8 May 2020

**Comments on the Project Profile for Tung Chung Line Extension (ESB-329/2020)**

**Figure 1.** The ecological and conservation importance of Tung Chung Bay and Tung Chung River are well-documented and was even proposed to be Sites of Special Scientific Interest by various environmental NGOs.

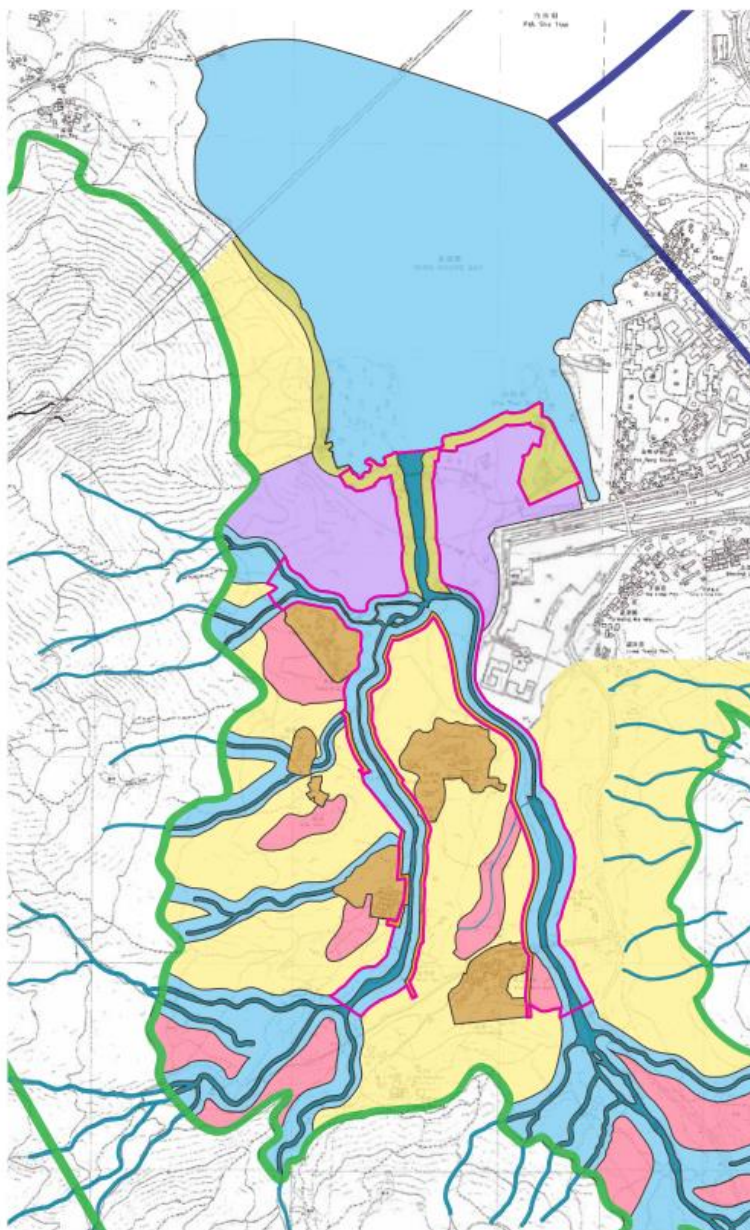
HKBWS is particularly concerned about the works associated with the proposed Tung Chung West (TCW) extension, as it is close to ecological sensitive receivers including Tung Chung Bay and Tung Chung Ecologically Important Stream, which their ecological and conservation importance are well-documented<sup>1</sup> and was even proposed to be Sites of Special Scientific Interest by various environmental NGOs<sup>2</sup> (Figure 1).

**Figure 3.** Slurry from the underground pressurized TBM excavation chamber leaked to aboveground through a plugged borehole, which flooded the Tam Kon Chau Road, damaged the structure of the affected fishpond and caused potential adverse ecological impacts on the nearby wetlands.

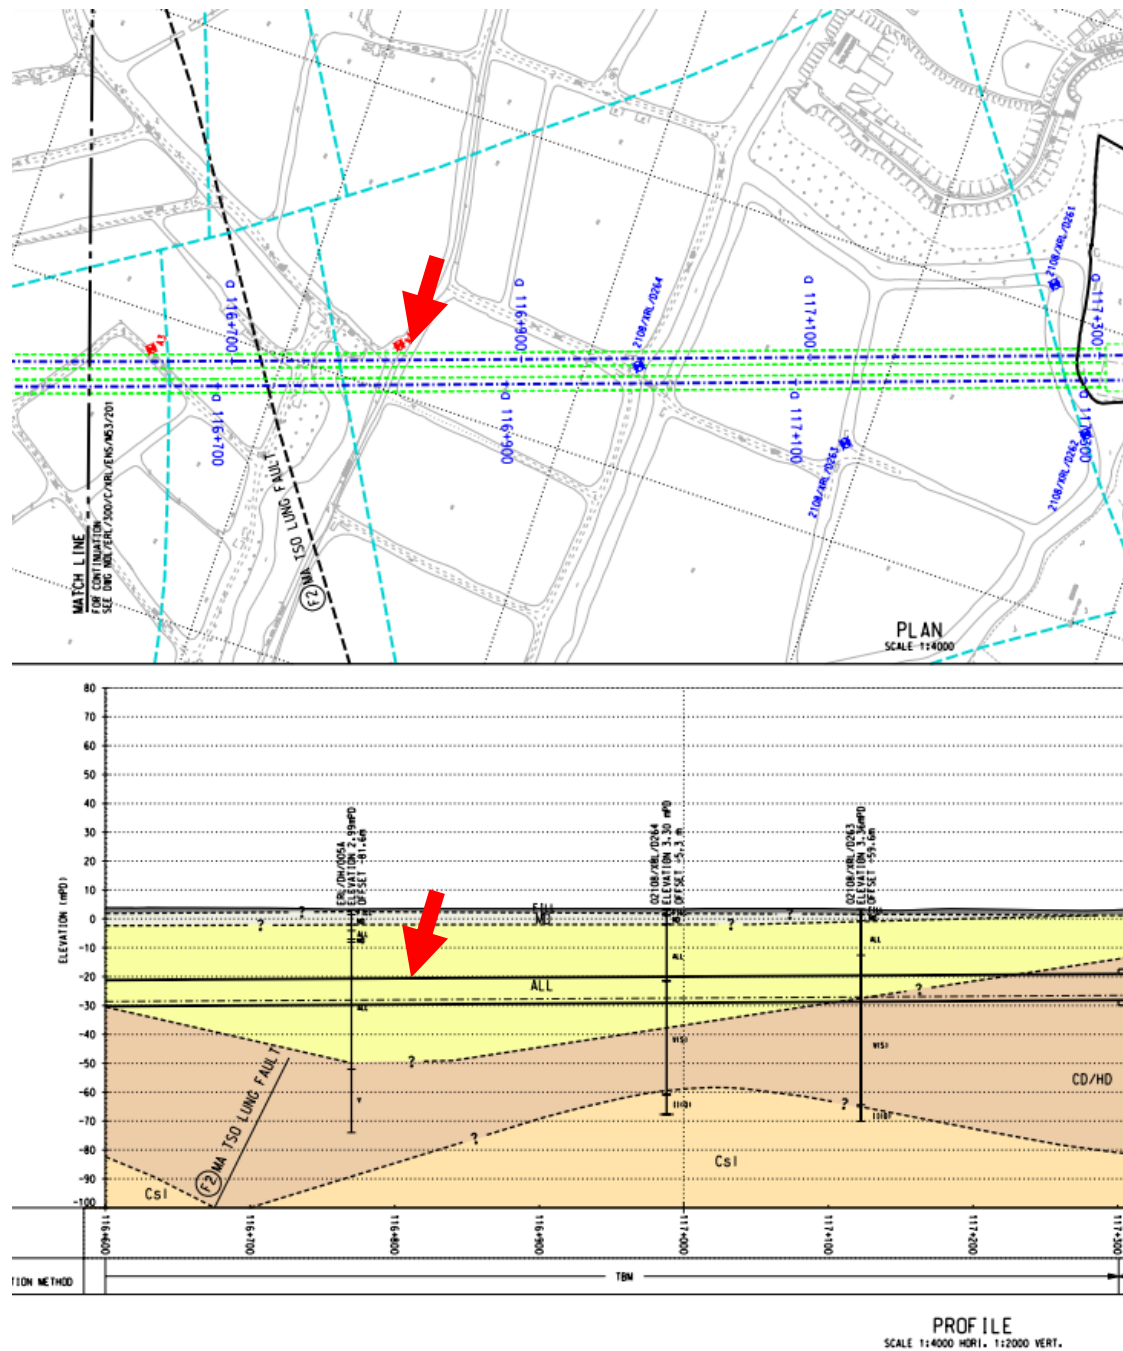
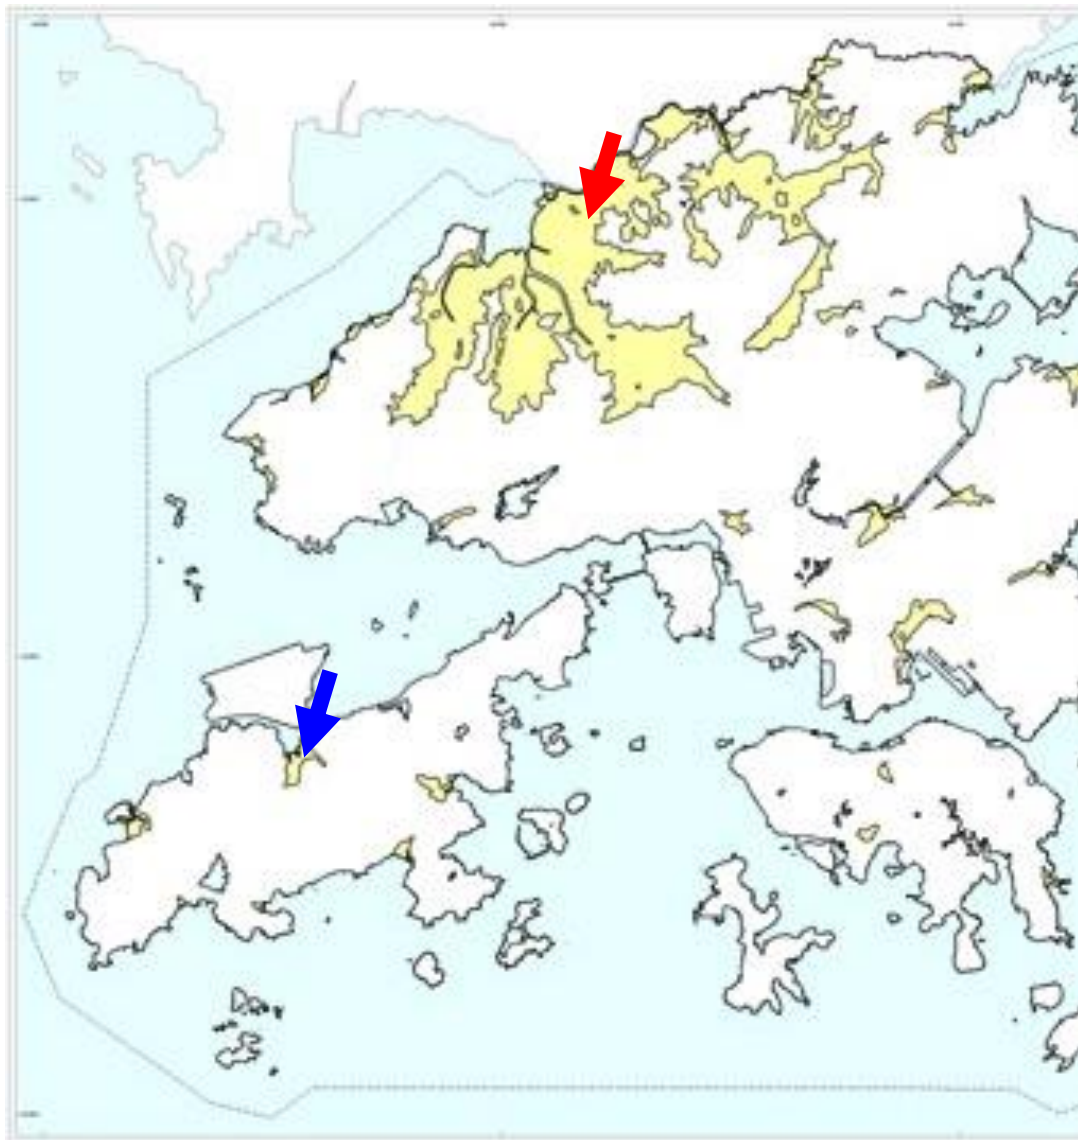
We recall an incident which occurred back in August 2015 when the construction and excavation works of the Express Rail Link were conducted approximately 25 metres under the fishponds at Mai Po (Figure 2). Slurry from the underground pressurized tunnel boring machine (TBM) excavation chamber leaked to aboveground through a plugged borehole, which flooded the Tam Kon Chau Road, damaged the structure of the affected fishpond and caused potential adverse ecological impacts on the nearby wetlands (Figure 3).
